**STAFF RECOMMENDATION**

**710 Shelby Street**

**July 20, 2016**

**Application:** New construction-infill

**MH A3.01**

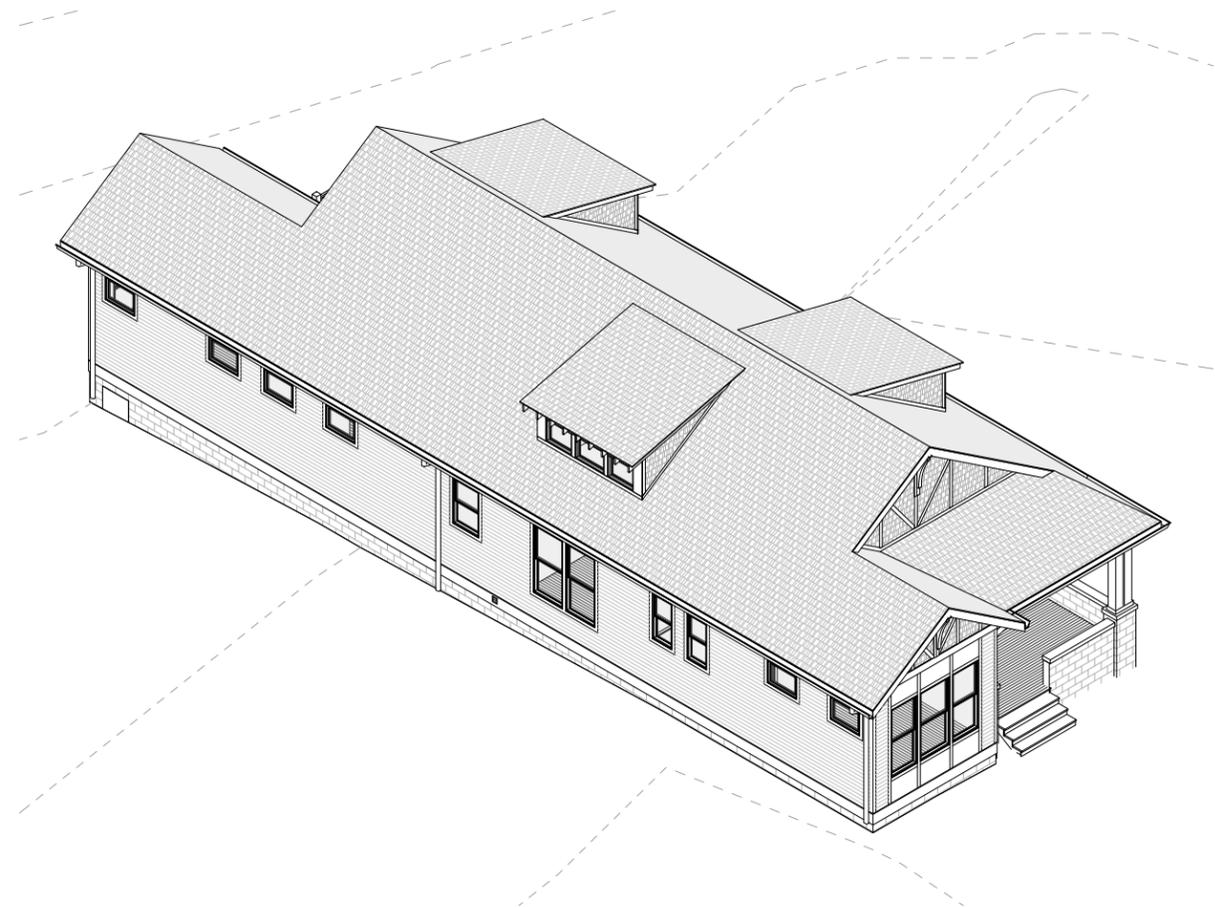
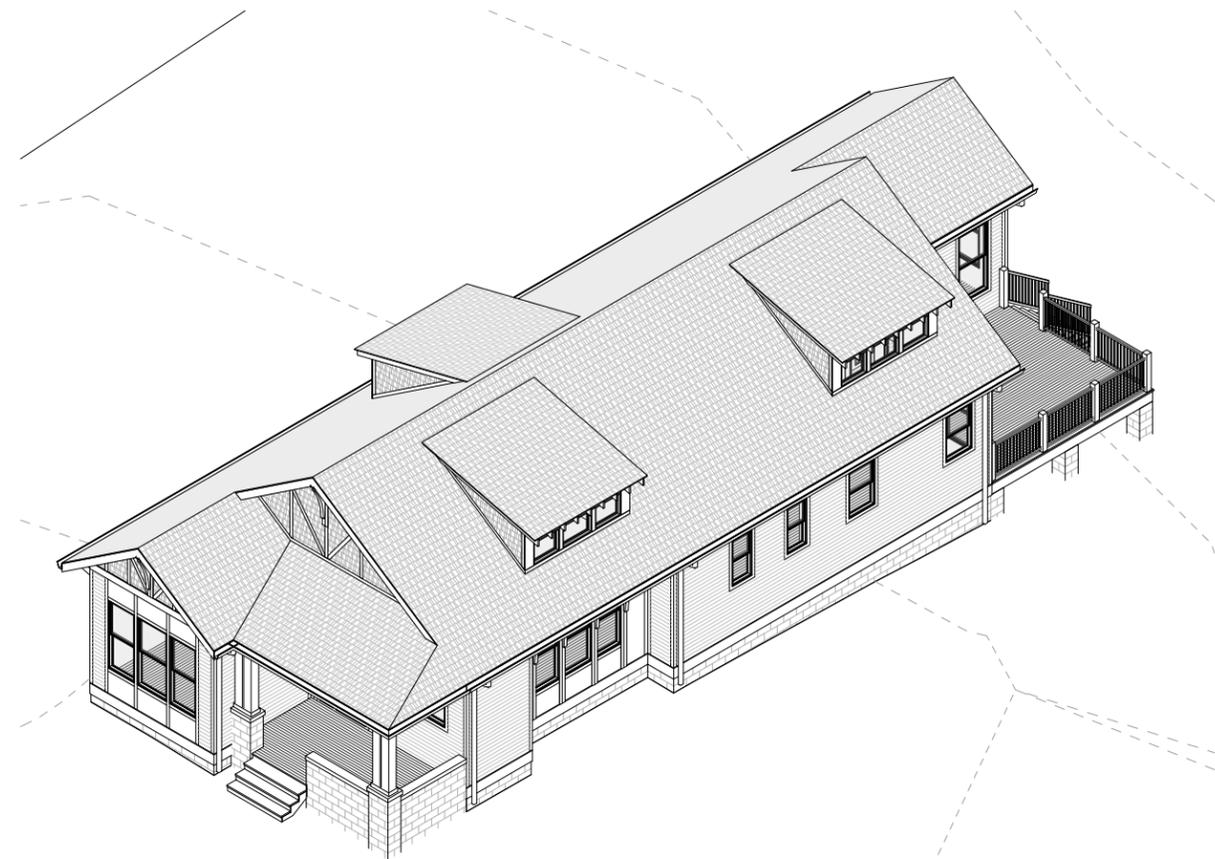
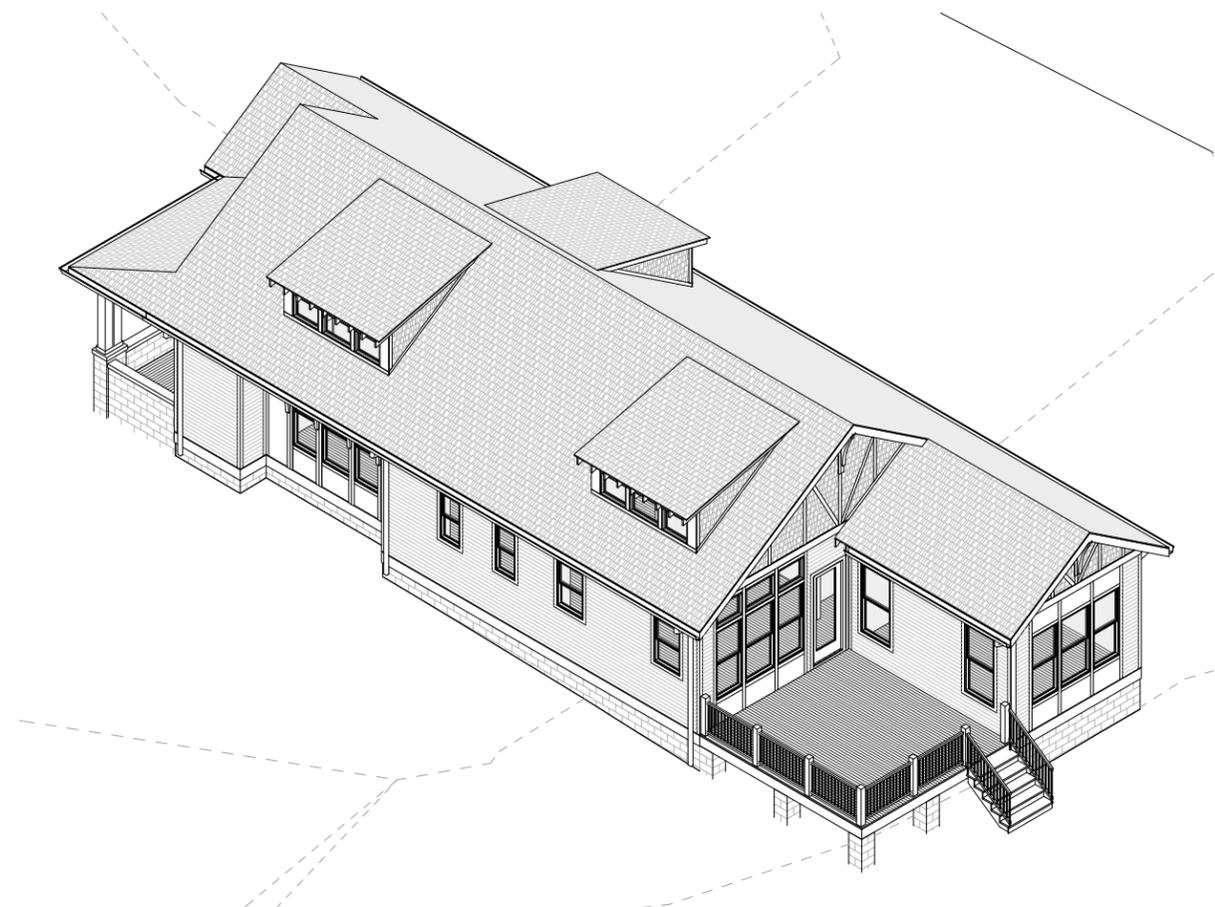
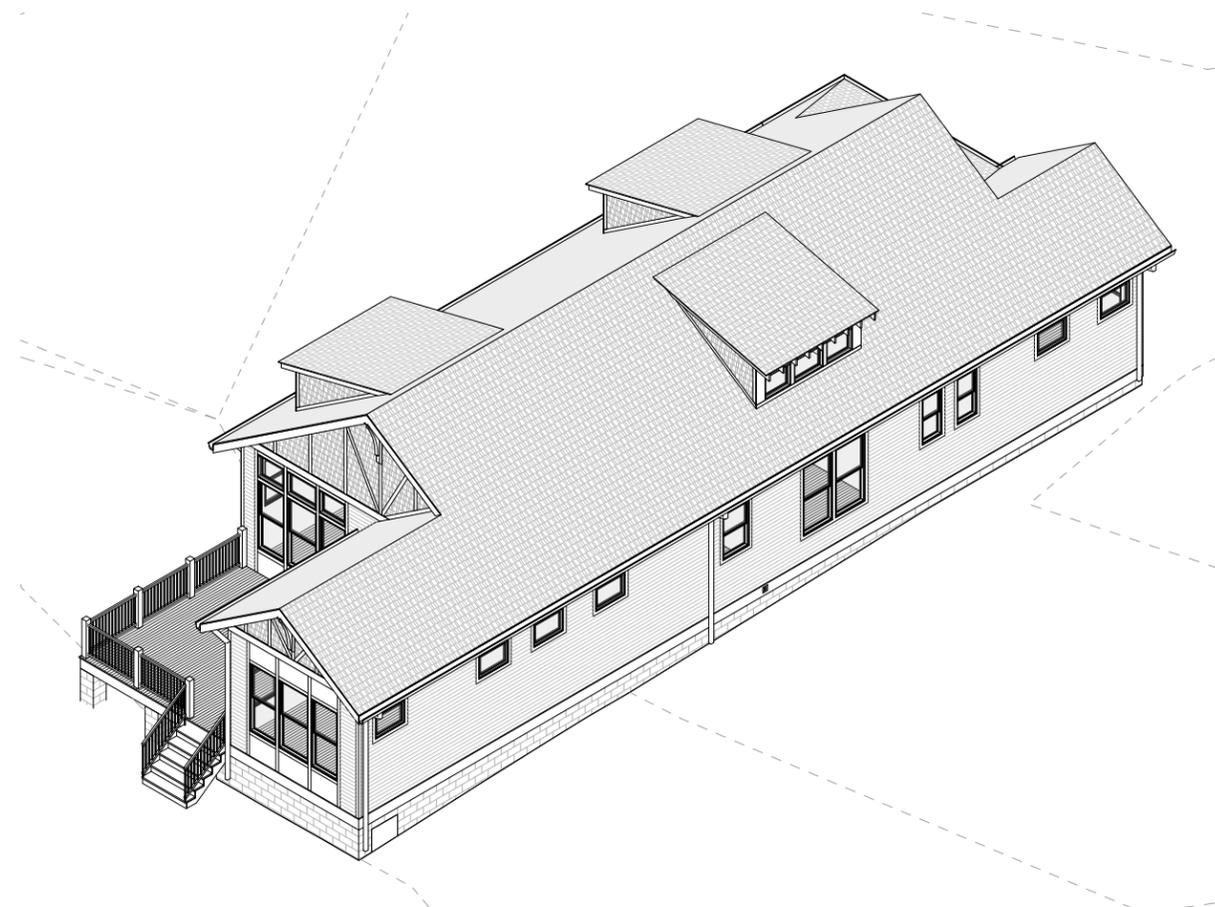
The mass of the building is essentially a single long rectangle. Historic buildings typically are not quite as long as the proposed and have bays and insets to break up walls. By moving the building to the right, as suggested under “Setback and Rhythm of Spacing,” this will allow the introduction of bays and/or insets to break up the approximately eighty foot (80’ 8”) wall.

Proportion and Rhythm of Openings: Toward the front of the house the windows are generally twice as tall as they are wide, typical of the proportions of historic windows, with the exception of the two front-most windows on the left side. Staff recommends making these two windows at least equally tall as they are wide or making them square so that that they do not have a horizontal orientation. Similar horizontally-oriented windows toward the rear of the side elevation will not be as visible; therefore Staff finds their proportions would not visibly contrast with the proportions of windows on nearby historic houses. There are no large expanses of wall space without a window or door opening. With a condition that the two front-most windows on the left side elevation are at least as tall as they are wide, Staff finds the proportion and rhythm of openings on the new building will meet section III.B.1.f of the design guidelines.

1. The finished floor height be consistent with the finished floor heights of the adjacent historic houses, to be verified by MHZC staff in the field;
2. The house be moved to the right three feet (3’);
3. The two front-most windows on the left side elevation are at least as tall as they are wide or square;
4. Staff approve the final details, dimensions and materials of windows, doors, walkway, and driveway prior to purchase and installation;
5. Location of drives and parking areas be at the rear, to be added to site plan;
6. Staff approve the roof color, dimensions and texture ; and
7. The HVAC be located behind the house or on either side, beyond the mid-point of the house.
